# Access Compliance Report

## Public Rights-of-Way

### (Pedestrian Signals)

Intersection ID: N/A	Main Street:	Cross Street: N/A	Location: N/A
ADA ID: BB5A5126C0E8	Signal Type: One Push Button-Non APS	Overall Compliance: No	Severity Score: BTN 1: N/A BTN 2: N/A No BTN: N/A
Codes/Mitigation Info/Possible Solution		Field Measurements/Component Compliance

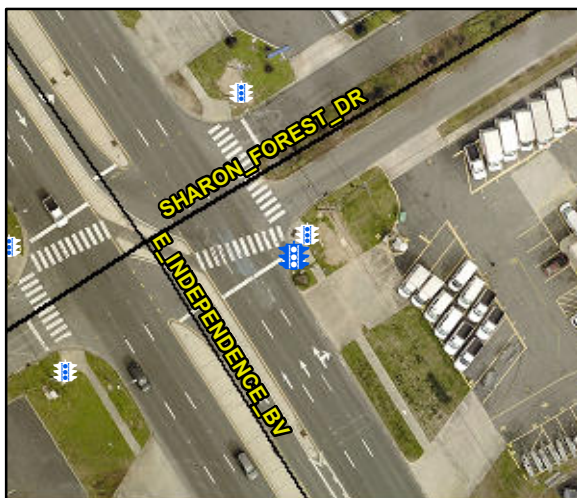
PROW/ADA: TMUTCD 4e.08, R404.2, R404.3, R406.2

Possible Solutions: Replace Signal Push Button With APS Button on New Post. Remove & Relocate Sign.
